**Independent External Review of
Crane Mountain Landfill**

**Crane Mountain Enhancement,
Inc.**

**ADI Limited
Report: (85) 5668-1.1
Date: November 2005**

Project No.	5668-001.1	
Dwg. No.	FIGURE 4-1	Rev. No. 0
Scale	1:5000

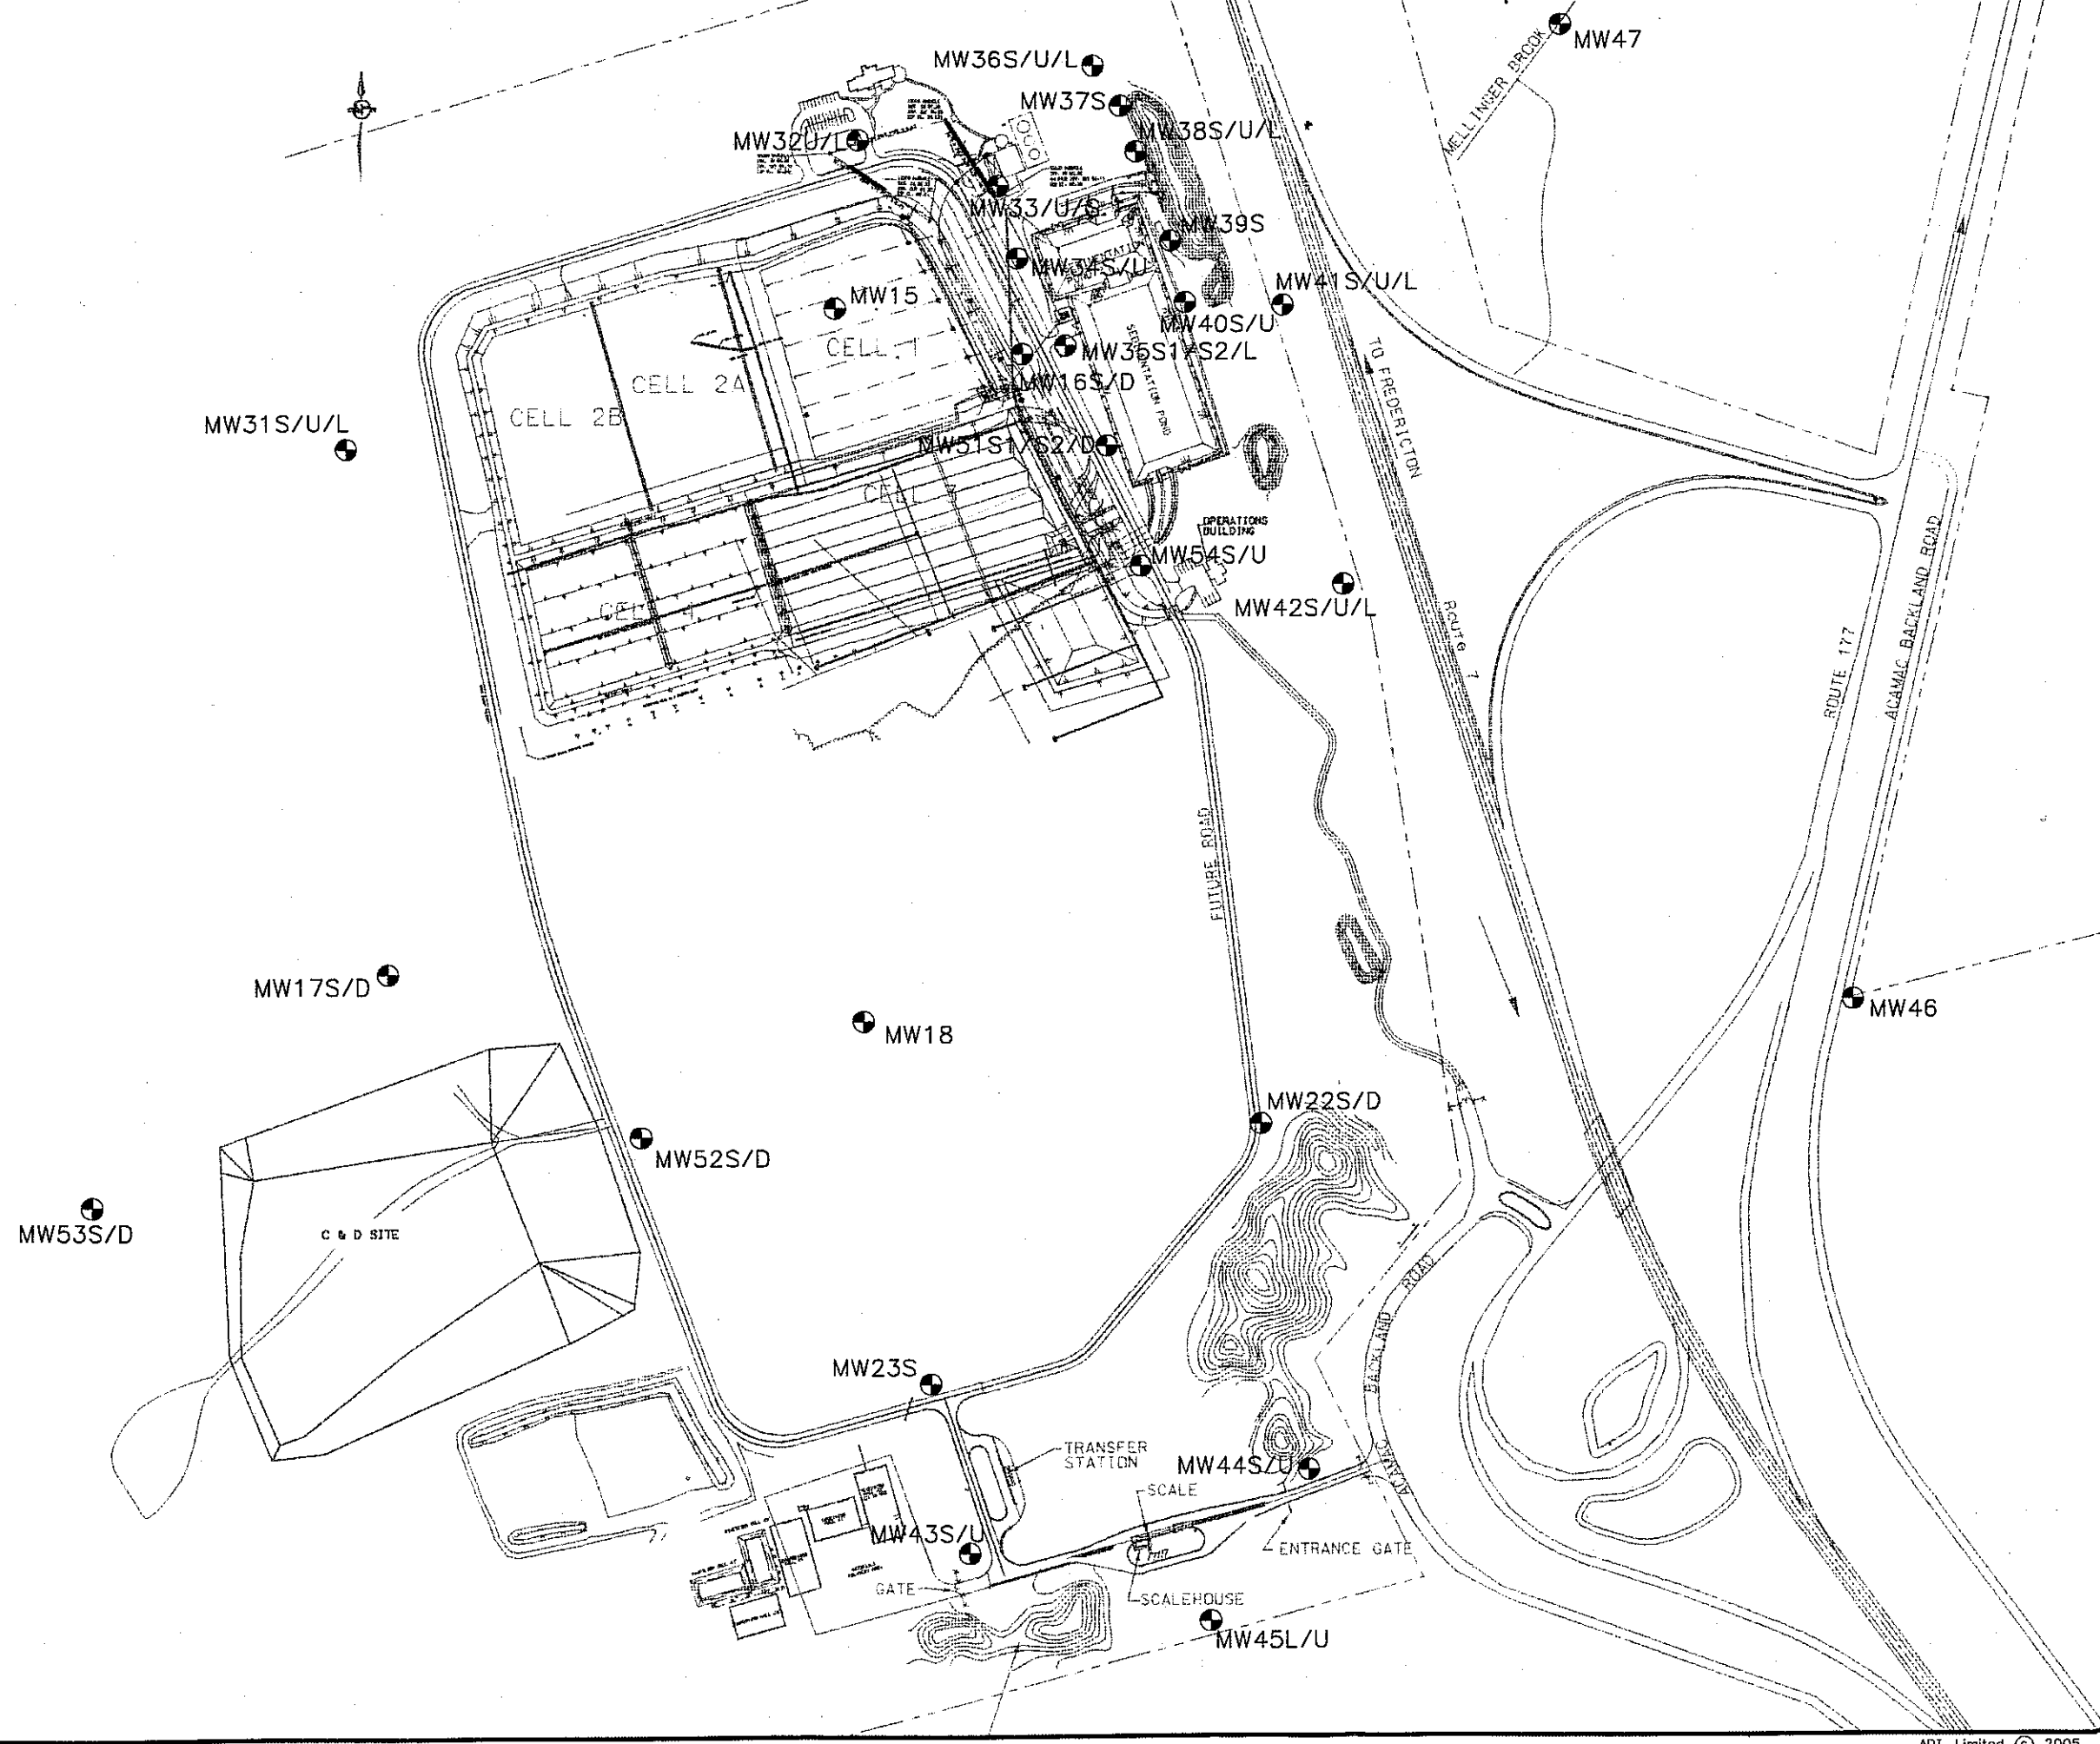
Regarding the main monitoring system installed in 1997, the network includes two angled boreholes (MW37A and MW39A) which were outfitted with multi-level groundwater monitoring installations. It is understood that the original monitoring network was designed

Sample Monitoring Well Results
Figure 4-2

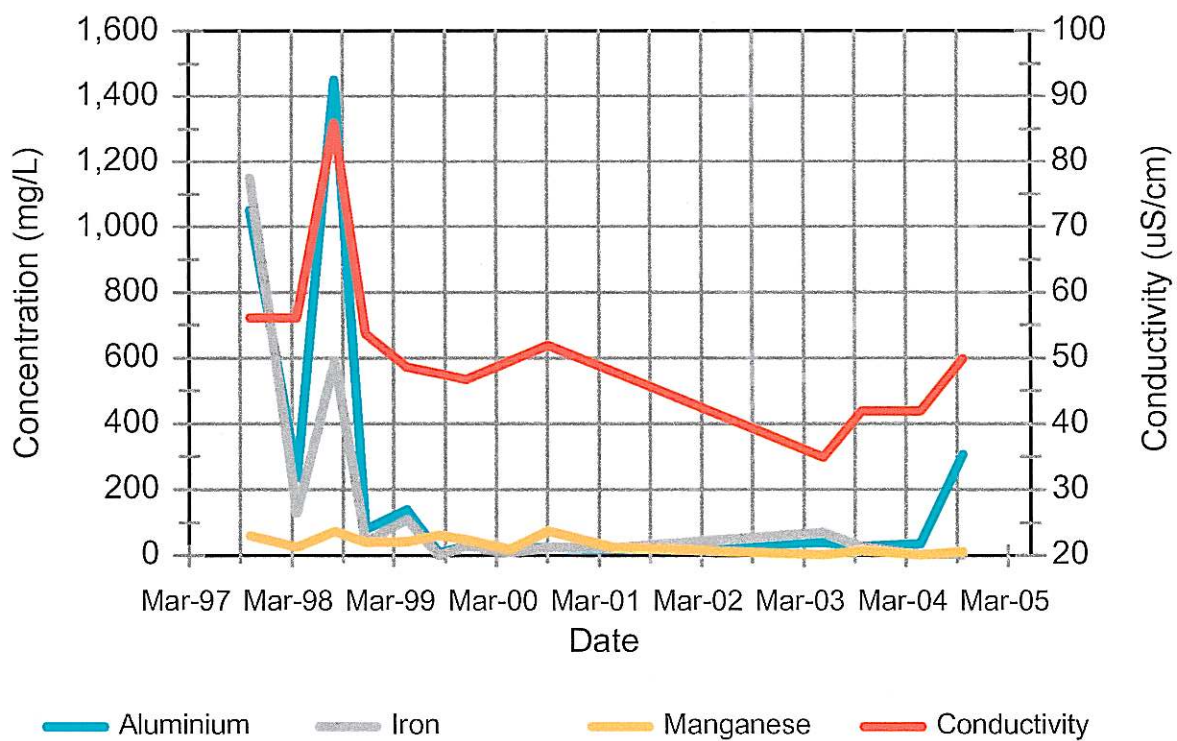
Some examples of analytical plots (trend plots) that would be useful in identifying analytical anomalies are shown in Figure 4-2. Such plots should be developed and maintained on an ongoing basis.

Dwg. Title
**CONCEPTUAL FINAL
 CONTOUR PLAN**

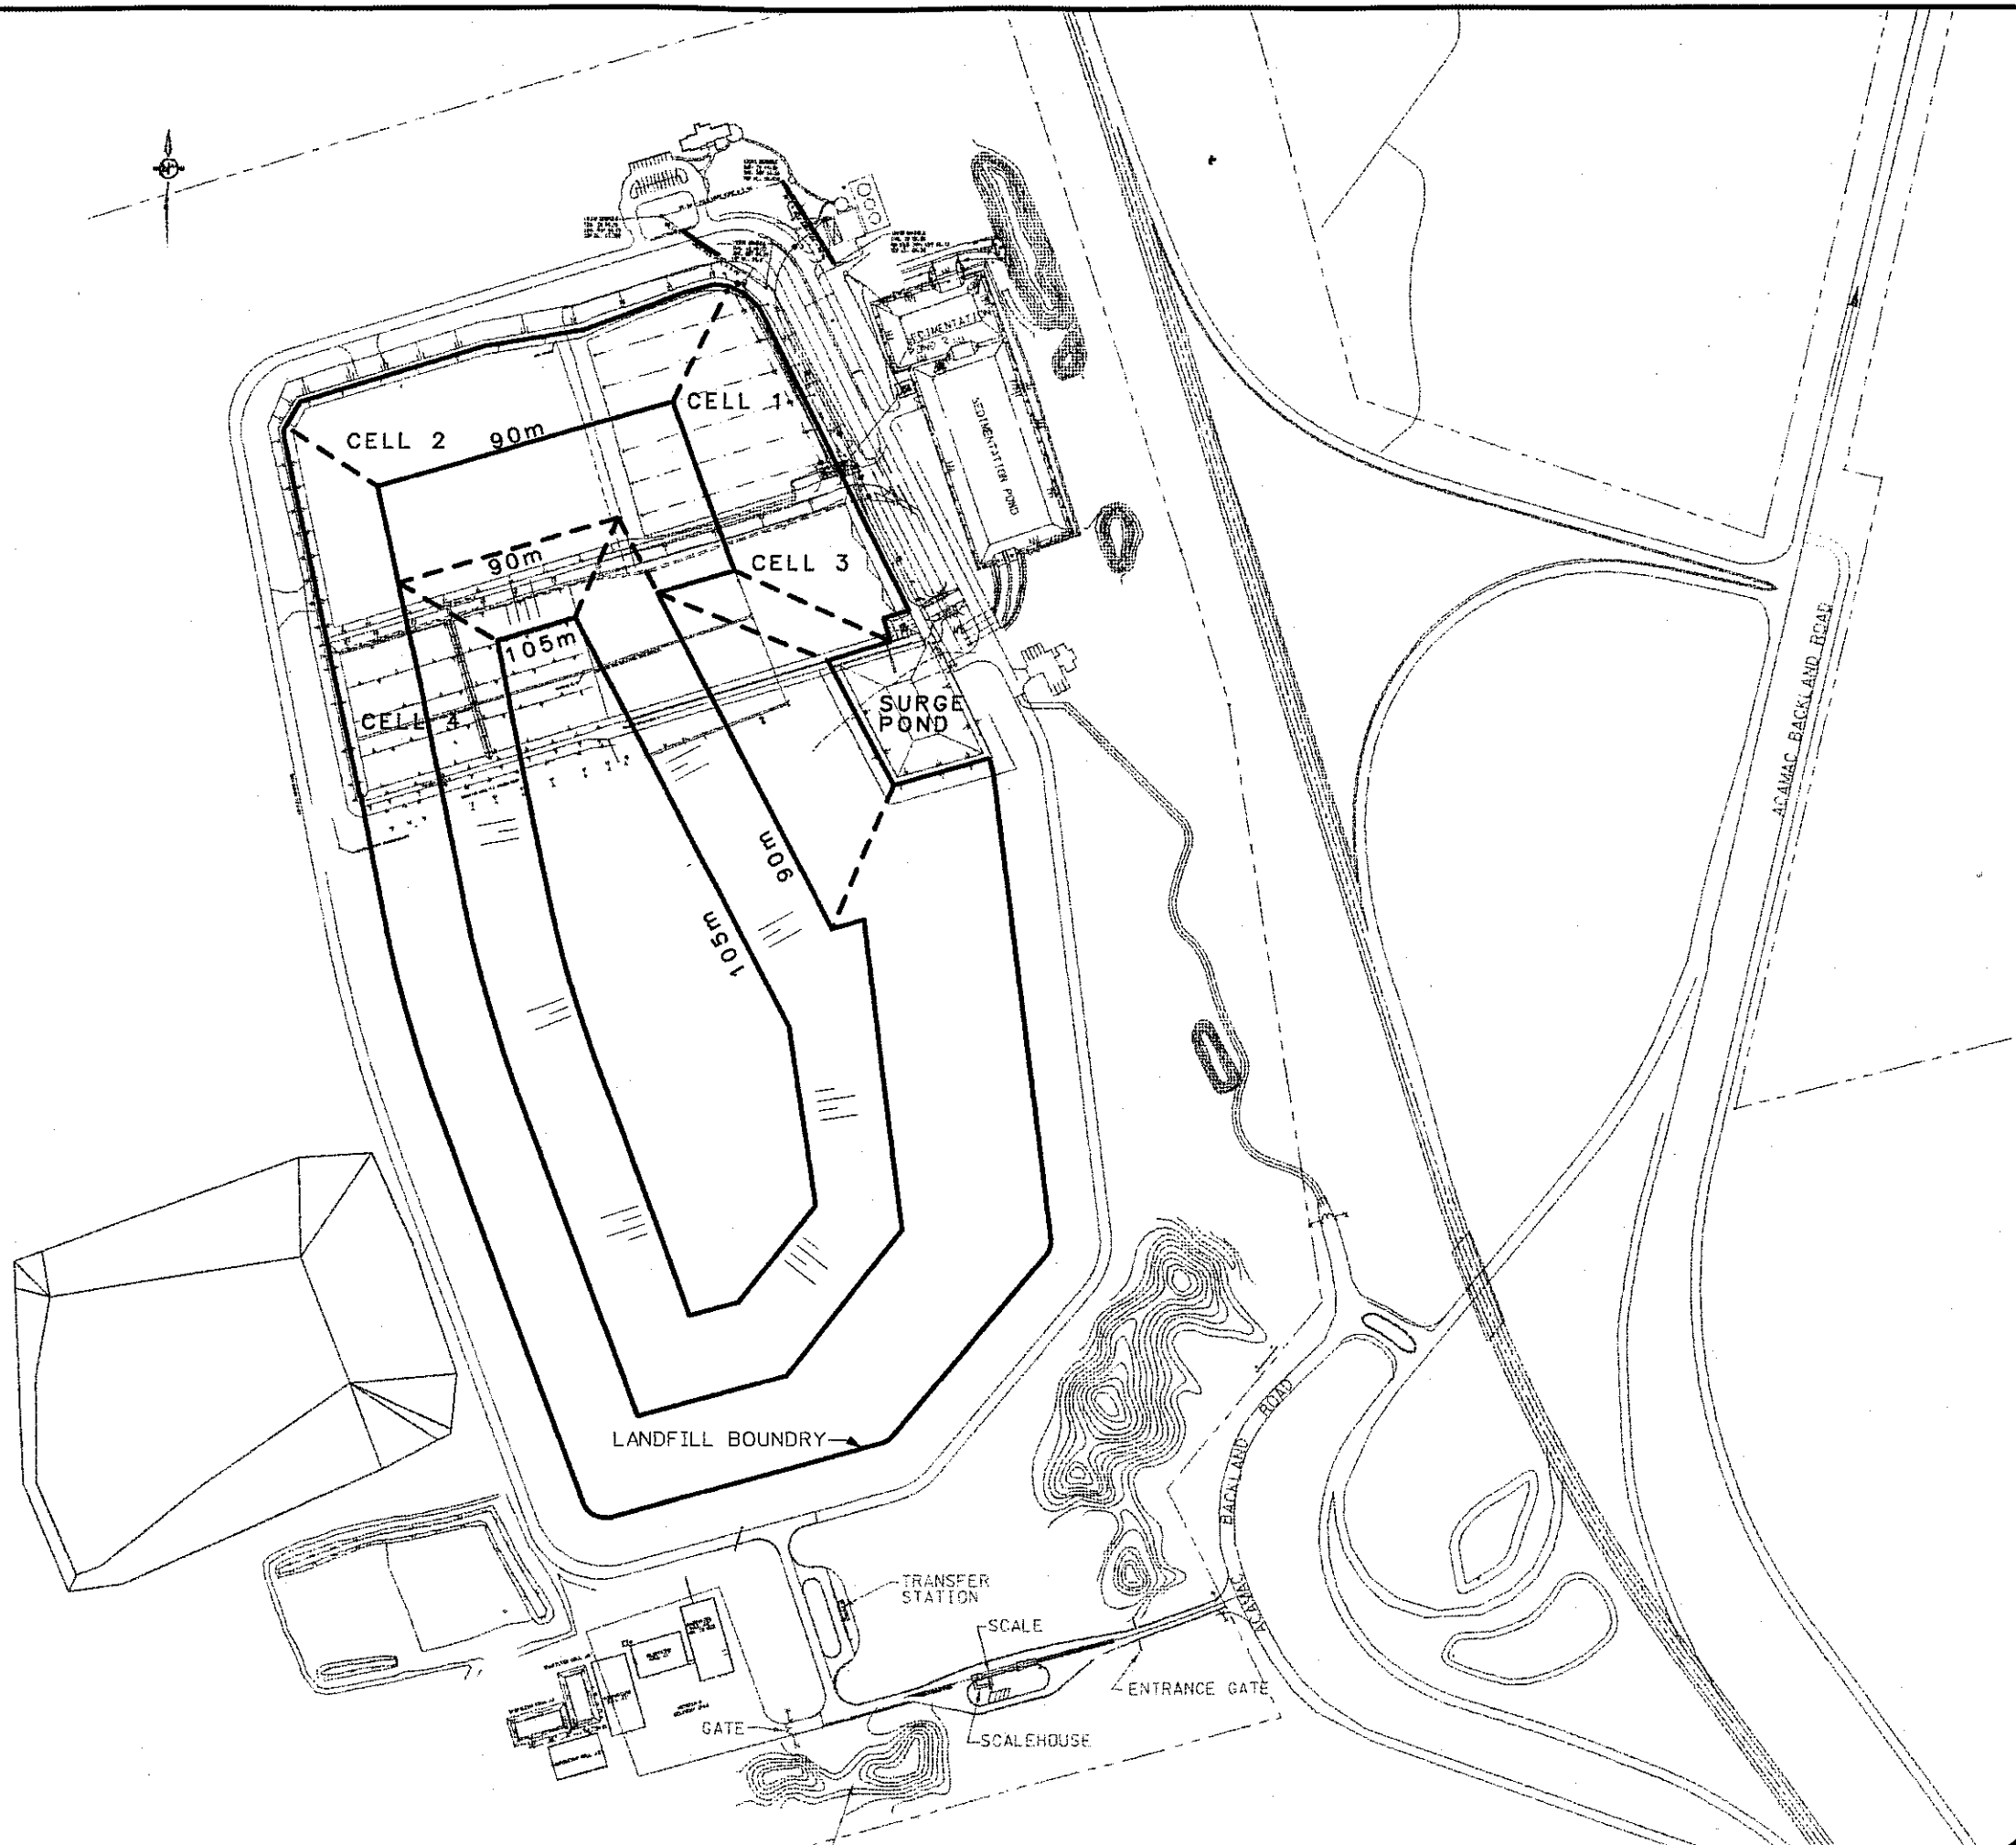
The concept of raising the height of the landfill has schematically been presented in the figures attached to the FRSWC application. It shows the layout of the finished landfill built up to the 105 m level. However, the plan does not include the Surge Pond, which we understand is meant to be a permanent facility at the landfill. It is therefore suggested that the concept plan be updated to reflect the Surge Pond, as well as the possible capping of Cells #1 and #2 at the 90 m level.

The Surge Pond creates a significant cutout in the landfill footprint, which changes the final contour plan. An approximate final contour plan is shown in Figure 5-5 which shows the final contours to the 105 m level with the Surge Pond incorporated into the concept. It becomes evident from this plan that Cells #1, #2 and #3 become partly isolated from the rest of the landfill and cannot effectively be raised to the 105 m level. Hence, these three cells should be brought to final grade for closure. It is noted that a portion of Cell #2 cannot be capped until the grades of the adjacent Cell #4 reach the 90 m level.

Dwg. No. FIGURE 5-6 Rev. No.

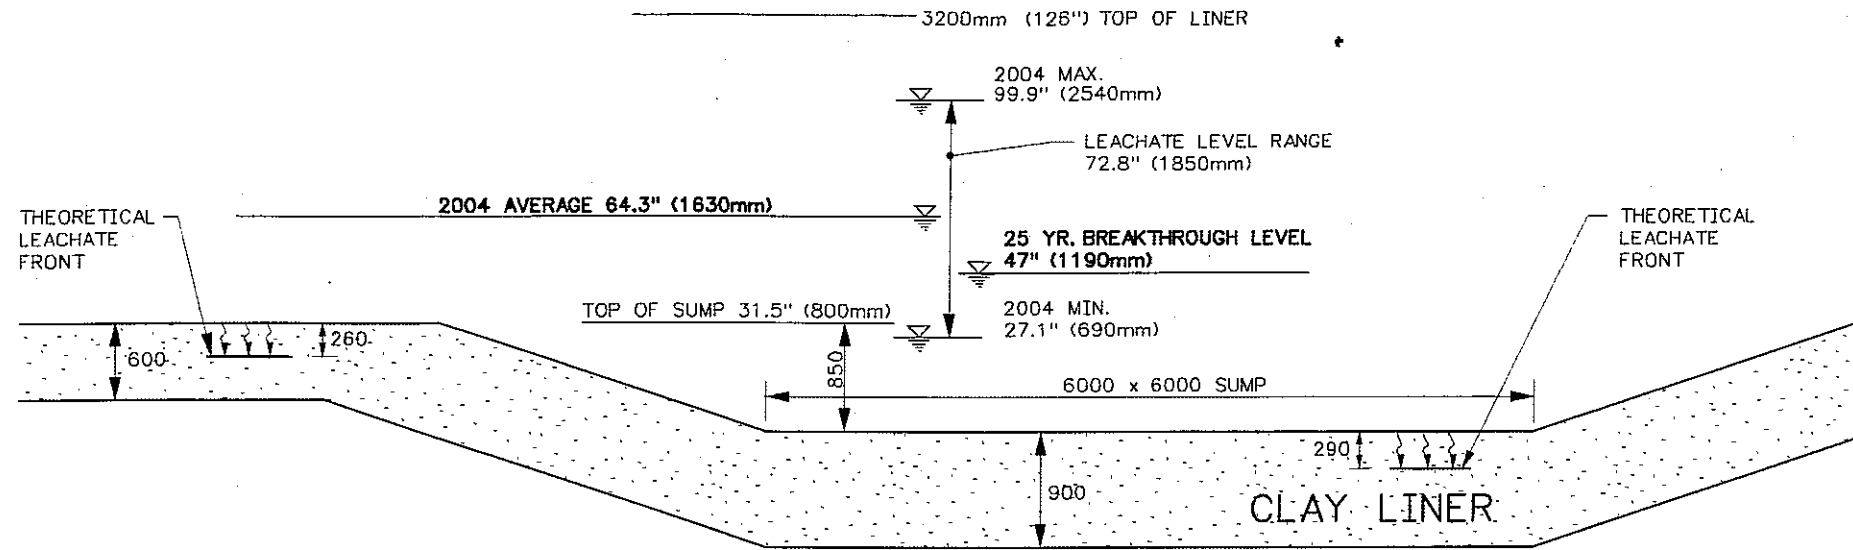
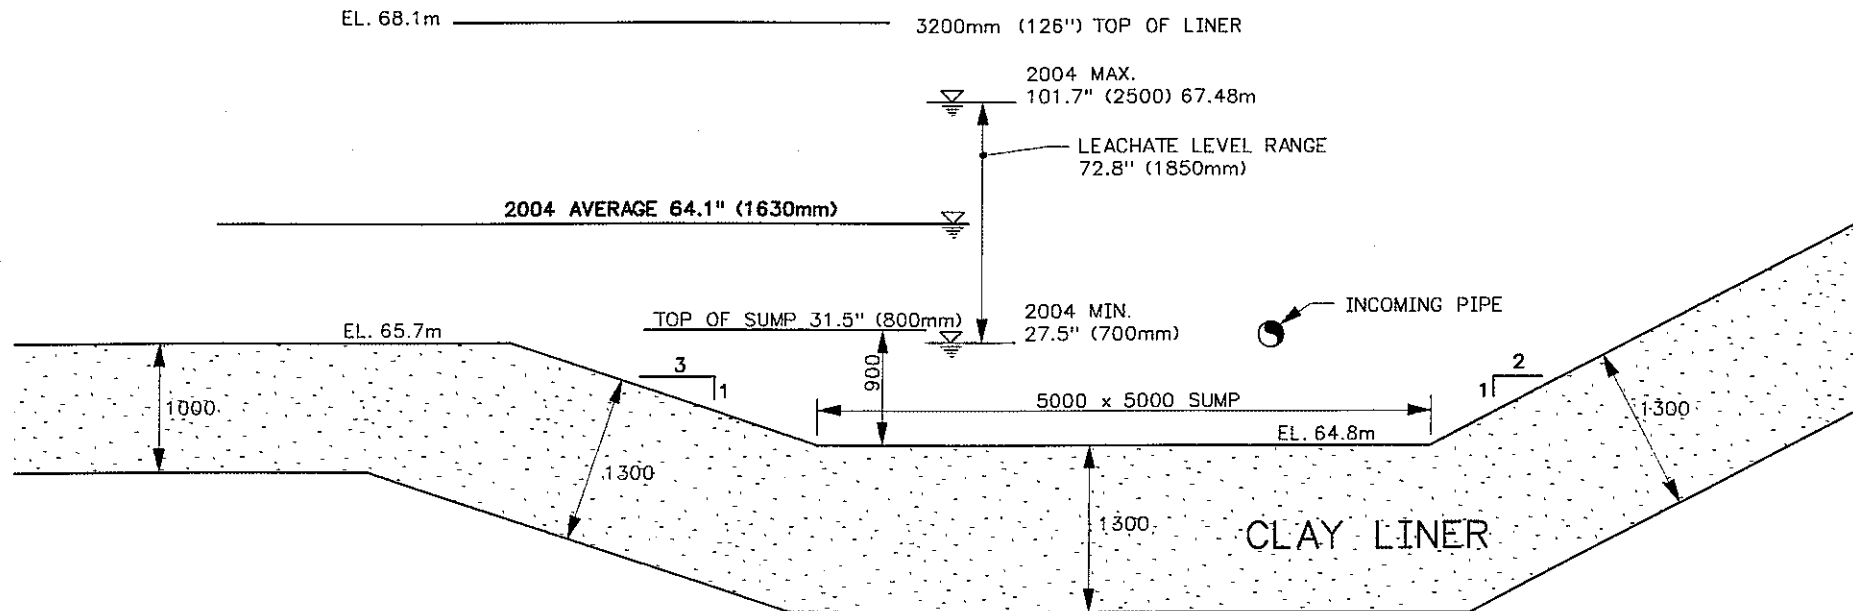
The leachate levels within the Cell #1 and Cell #3 sumps are measured daily, except on weekends. The recorded data is summarized in the following tables. Figure 5-6 shows the cross-sections of the two sumps and the associated leachate levels.

The 2004 annual average leachate level in the two sumps were very similar at 64.1 and 64.3 inches. This leachate head is greater than the maximum average value of 47 inches needed to meet the 25 year breakthrough criteria for the Cell #1 600 mm thick liner (June 21, 2005 Gemtec letter regarding Review of Leachate Breakthrough Through Clay Liner). It is also noted in the same letter that the theoretical leachate penetration of the clay liner would be 260 mm in the Cell #1 liner and 290 mm in the 900 mm thick Cell #1 sump. These calculations are based on the clay barrier only, and would therefore theoretically represent an assumed leak in the HDPE liner since the landfill began operation.

To meet the design objective of a minimum 25 year breakthrough time in the clay liner, it is recommended that the leachate level within Cell #1 be maintained as low as possible at all times. At present the leachate level is affected by the frequency in which the leachate pumped to the tanker trucks for transport to the Lancaster treatment facility. The leachate level could be lowered by increasing frequency of pumping out the sumps. As an initial measure, consideration could be given to automating the system so that the excess leachate is pumped directly to the Surge Pond. The long term solution, which the FRSWC is evaluating, is to construct a pump station and forcemain that would discharge at the Lancaster treatment plant. This would allow direct pumping of leachate to the treatment plant.
